**AN - MAINT/MECH. BLDG.**

**ROOF PLAN - AREAS A, B, C & D**  
 NORTH  
 1" = 20'

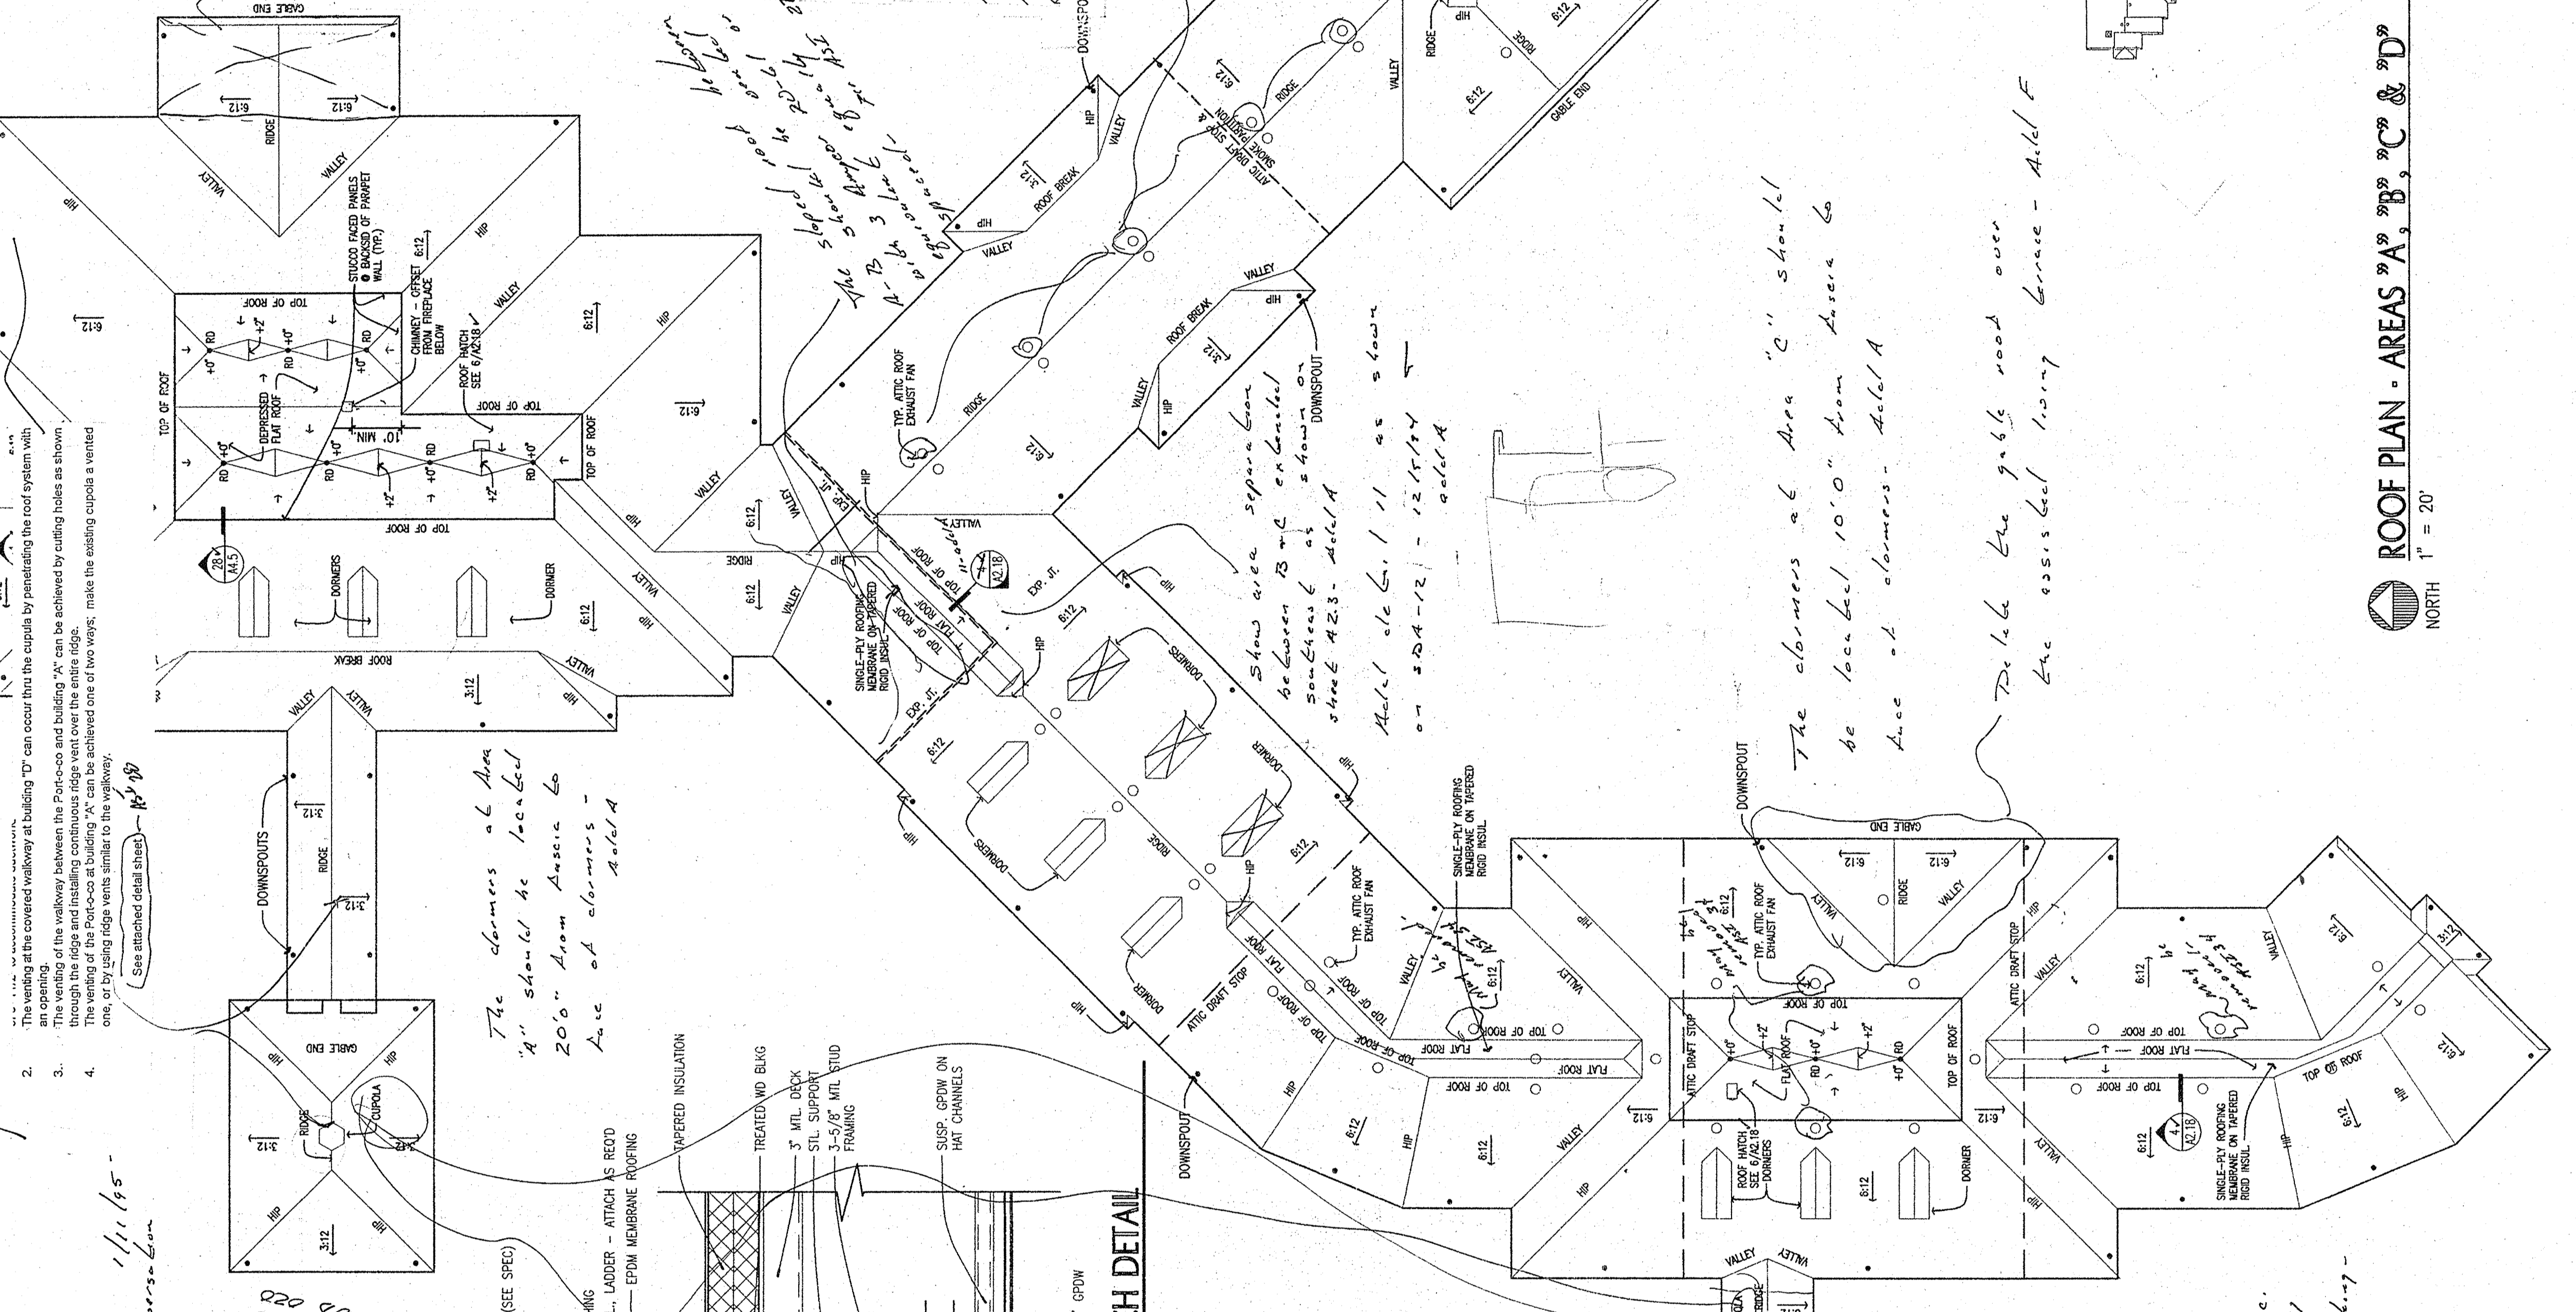
*Detail public road over curb / dining terrace per SDA-30 - All F. All ball covered roof @ A per attachment 6 - PL 32*

*May be removed per ASE 34*

*See attached detail sheet 10-18*

*The dormers at Area 'A' should be located 20'-0" from Areas B, C & D*

*Show area separation between B & C enclosed dormers at show DOWNPOUT sheet A2.3. All F*

*The dormers at Area 'C' should be located 10'-0" from Areas B, C & D*

*The table the public road over the essential dining terrace - All F*

**1 - RIDGE DETAIL**  
 1-1/2" = 1'-0"

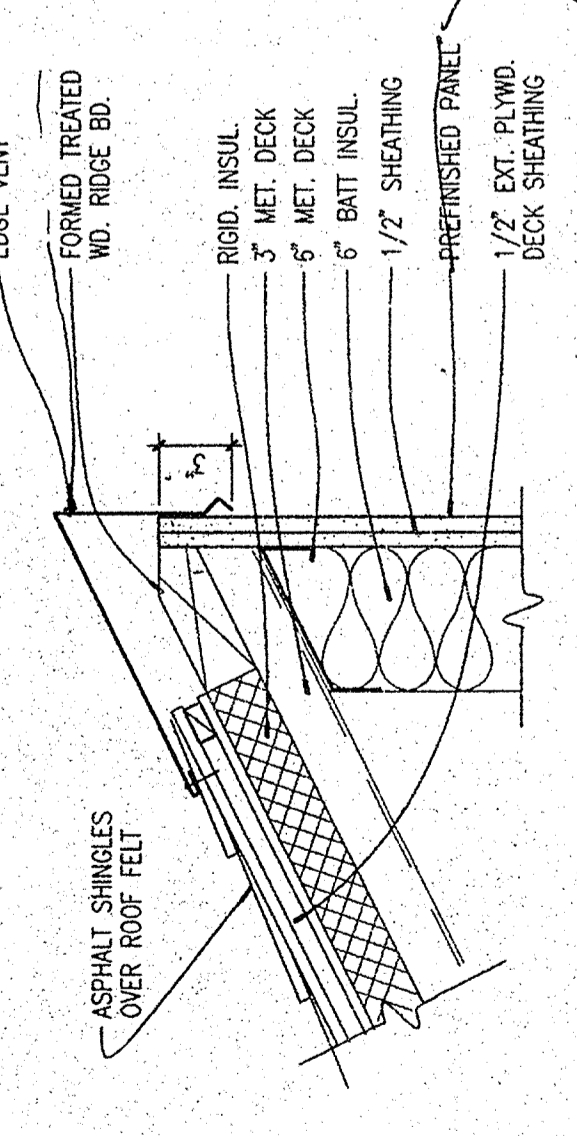
*Trade copper angles @ 4" x 4" copper per arch construction*
